# Sheringham Shoal and Dudgeon Offshore Wind Farm Extension Projects

The Applicant's Comments on Post-Hearing Submissions

Document Reference: 14.6

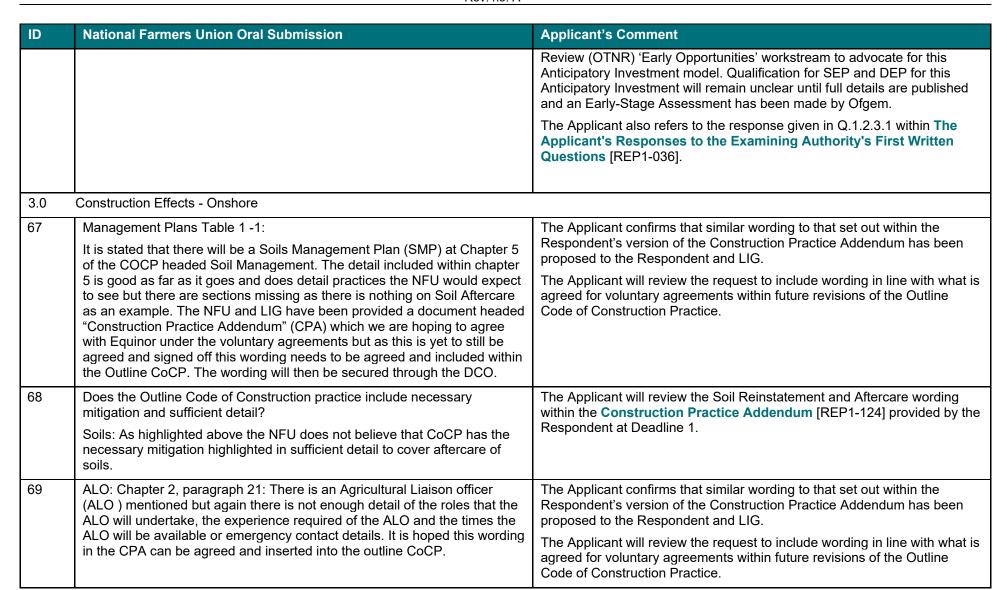
2.0	Development Scenarios.	
64	How is the preferred scenario decided:  The NFU understands that Sheringham Shoal and Dudgeon are separate projects and have separate ownership other then Equinor has an interest in both projects. We also understand that Equinor is doing something different by the application for the DCO being for both projects. Equinor at the hearing stated that they need all scenarios applied for within the application. The NFU believe that the best case scenario must be taken forward by Equinor which would reduce the construction time so reduce the impact on landowners and farmers. Therefore it is really important that measures are included within the DCO that will make sure and compel Equinor to take the preferred scenario forward which has a single construction phase.	As set out in the <b>Scenarios Statement</b> [APP-314] all of the scenarios set out in the <b>draft DCO</b> ( <b>Revision D</b> ) [document reference 3.1] are required for the development of SEP and DEP. As explained in the Applicant's response to Q1.6.1.1 in <b>The Applicant's Responses to the Examining Authority's First Written Questions</b> [REP1-036], the final chosen development scenario is dependent on a number of factors, some of which are outside of the Applicant's direct control, such as the need for changes to the regulatory regime around CfD and Anticipatory Investment to enable an integrated grid connection to be delivered. These factors will be considered post consent when there will be further certainty as to the regulatory position that will apply at that stage and therefore flexibility within the <b>draft DCO</b> ( <b>Revision D</b> ) [document reference 3.1] with regards to all the specified scenarios must be maintained.
